Application No. 10/524,244
Reply to Office Action of June 12, 2006

AMENDMENTS TO THE DRAWINGS

REMARKS

FIG. I

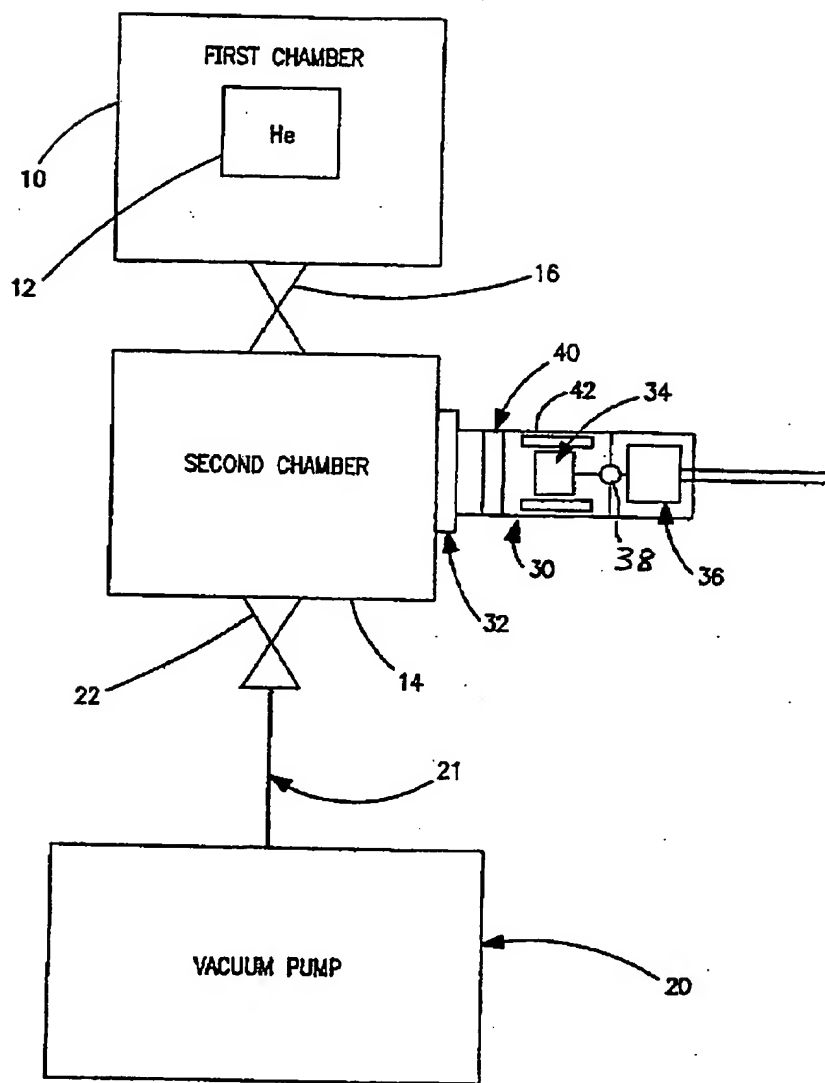
The Examiner has objected to the drawings because Fig. 5 should be designated by a legend such as prior art, because the drawings do not include reference signs mentioned in the description and because the drawings include a reference sign not mentioned in the description. Enclosed herewith are proposed amended drawings, with changes marked in red. In the amended drawings, Fig. 5 has been designated as prior art. Fig. 1 has been amended to show reference sign 38. Fig. 5 has been amended to show reference sign 236. Reference sign 50, shown in Fig. 1A, represents a heating element. The specification has been amended at page 6, line 31 to change "conduit 50" to "conduit 60," as illustrated in Fig. 3, thereby correcting an obvious error. Reference sign 60 is now mentioned in the description at page 6, line 31, and at page 7, line 3. Approval of the corrected drawings and the amendment to the specification is respectfully requested.

New Figs. 1 and 5 are attached following page 14 of this paper.
